CITY OF FRANKLIN  
PLAN COMMISSION MEETING\*  
FRANKLIN CITY HALL COUNCIL CHAMBERS  
9229 W. LOOMIS ROAD, FRANKLIN, WISCONSIN  
AGENDA  
THURSDAY, SEPTEMBER 23, 2021, 7:00 P.M.

**City of Franklin**  
**Plan Commission Meeting**  
**September 9, 2021**  
**Minutes**

Date: September 15, 2021  
To: Plan Commission  
From: Department of City Development. Régulo Martínez-Montilva, Principal Planner  
RE: Informational Hearing for Franklin Aggregates Reclamation Plan

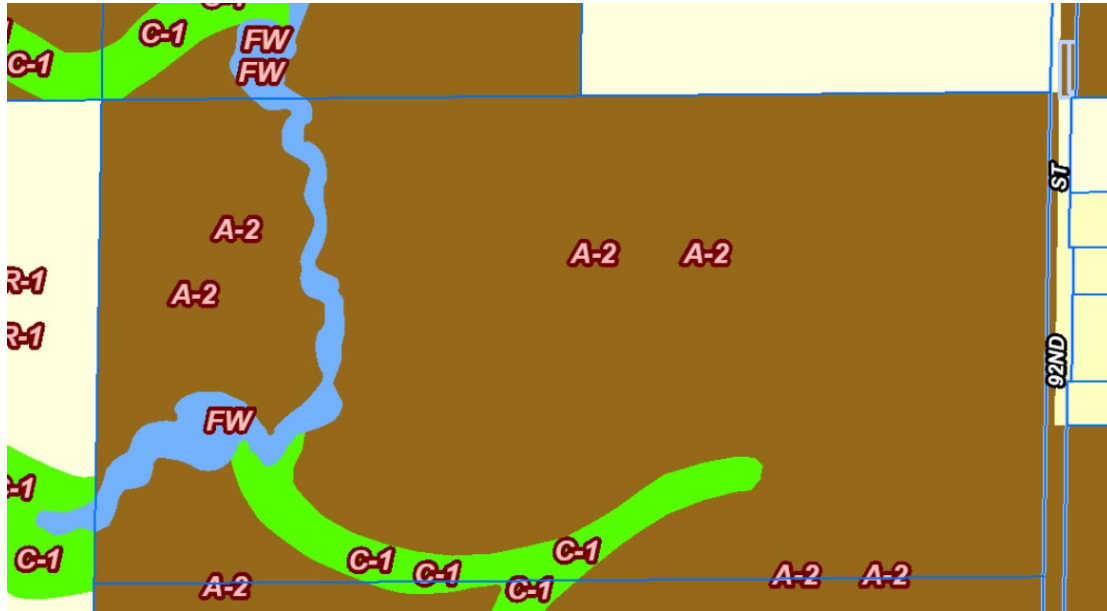
Please add the 30-foot wetland buffer and the 50-foot wetland setback.

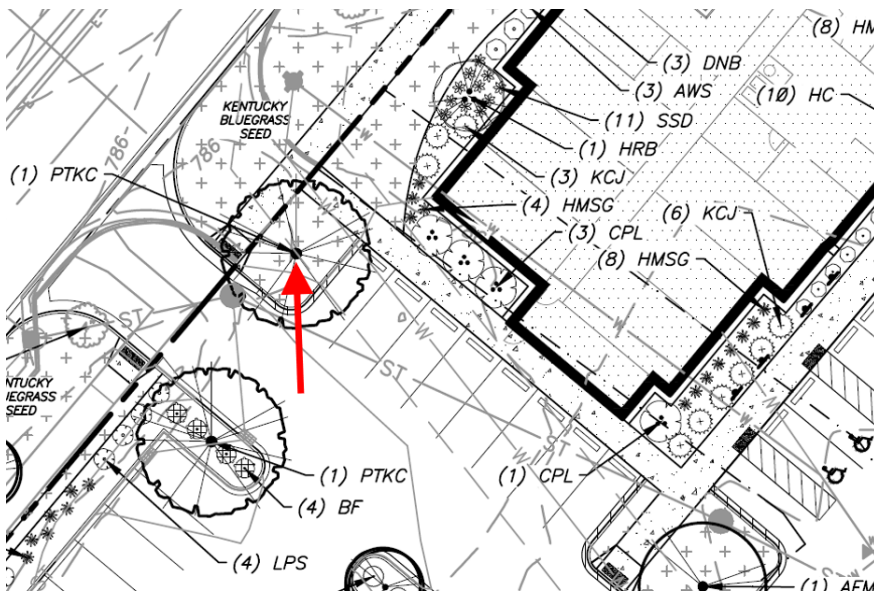
8. **Number of parking spaces.** According to PDD Ordinance §15-3.0442E(B)(b), *parking lots in which the number of spaces significantly exceeds the minimum number of parking spaces required*

11. **Parking islands are too long.** Pursuant to PDD Ordinance §15-3.0442E(B)(4)(c)(ii), *landscaped islands shall be three (3) feet shorter than the depth of any adjacent space.* The provided parking spaces are 20-ft long, so the parking islands must be 17-ft long, measured from the inside of the curb. Please revise parking islands, see parking below in Lot 1 as an example.

SHEET NUMBER:  
**C1.0**

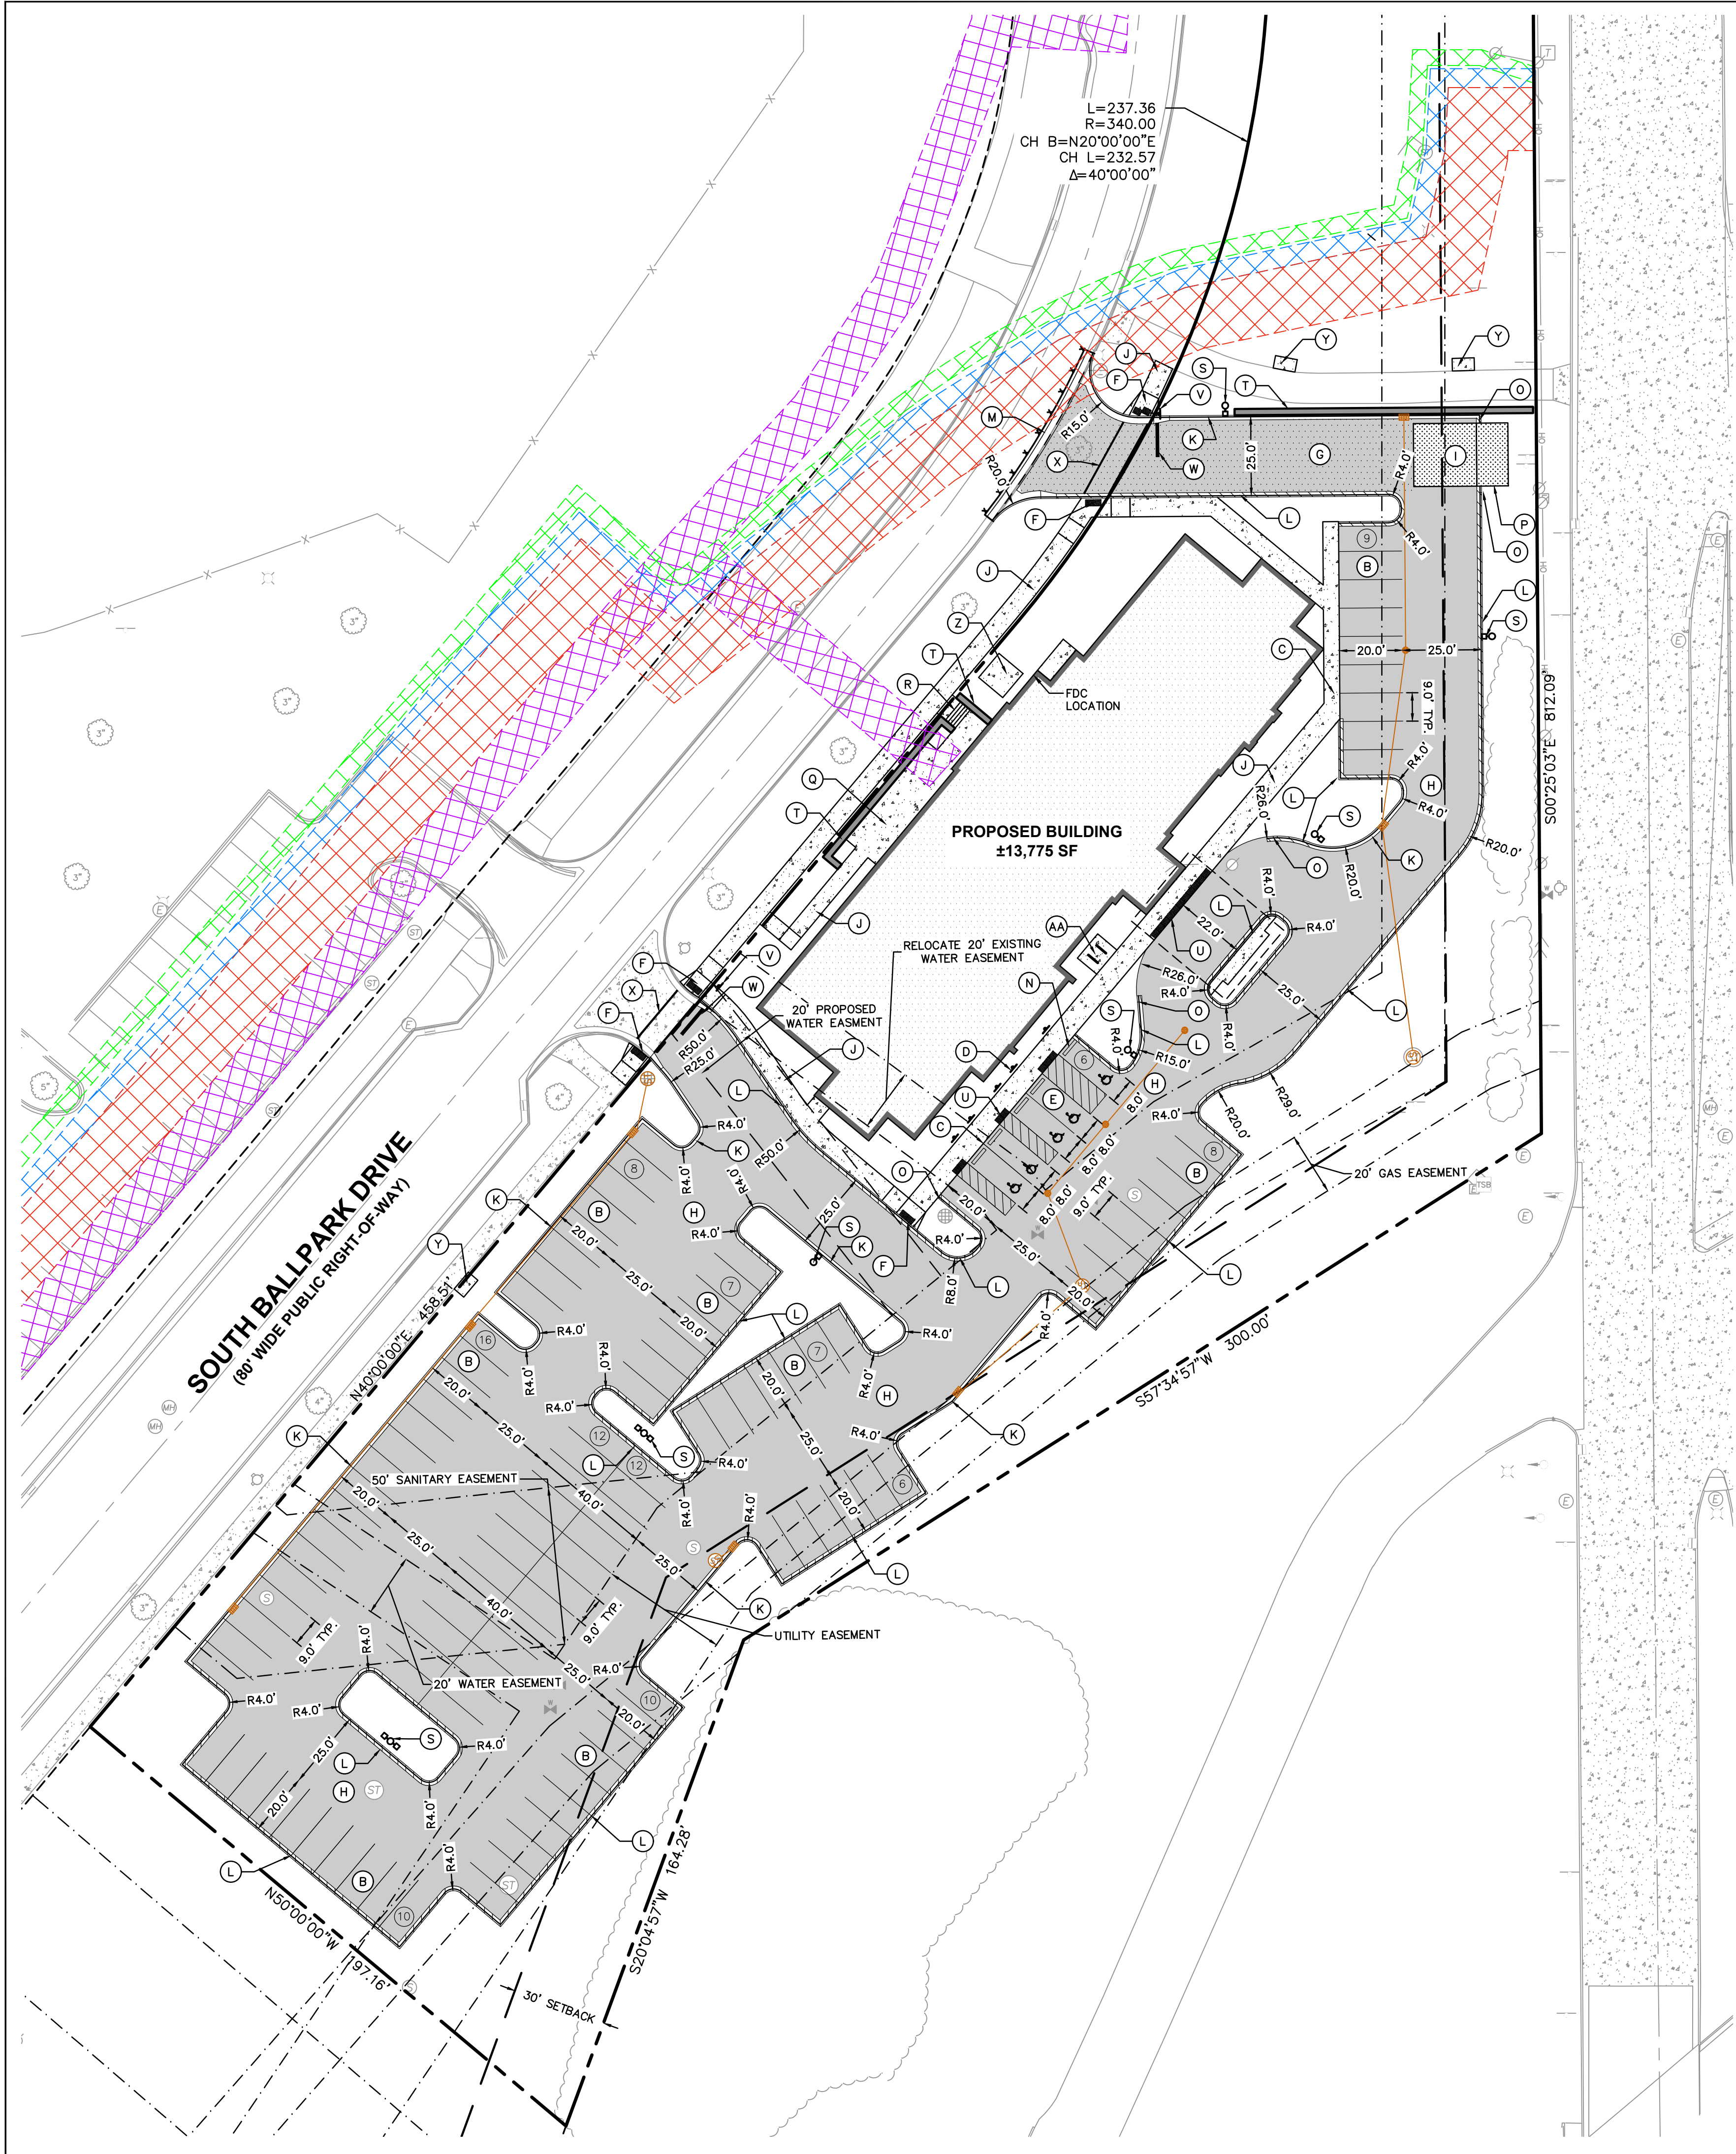
*Refer to C1.0 – Site Plan for all existing and proposed easements. We confirmed with City Engineering at the pre-application meeting that paving and curbs would be allowed over the existing easements.*

*Refer to C1.0 – Site Plan. Located between the building and Ballpark Drive is a patio area (key-note “Q”). This amenity is accessible to the public and connected to adjacent public walks, but is generally intended for hotel guest use.*
